DSOX96204Q-01

S E R V I C E N O T E

DSOX96204Q - Infiniium High-Performance Oscilloscope: 63 GHz

Example of the data flyers:

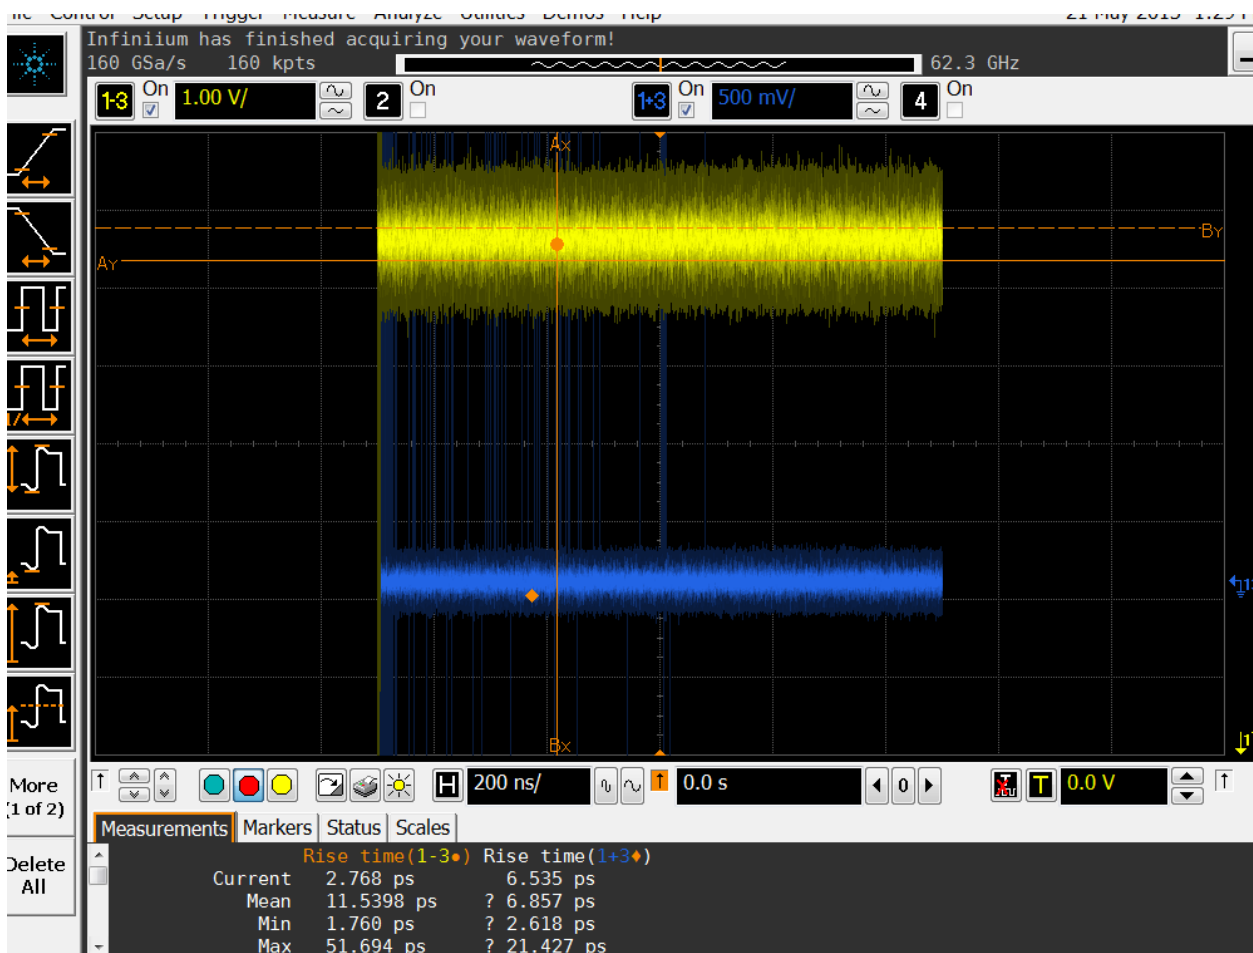
Using the Real Channels with differential mode on and or Precision Probe on, causes the Main FPGA to dip and data fryers are observed due to voltage variations.

Starting in July 2013 week 33 and ECO was implemented changing the power supplied to the Main FPGA. This fixed the Real channels having Data Flyers due to voltage variations. Scopes shipped previous to this ECO need to be updated to the reworded Backplane assembly.

Replace Backplane assembly following the service manual procedure. Factory Calibration is required after the backplane replacement.
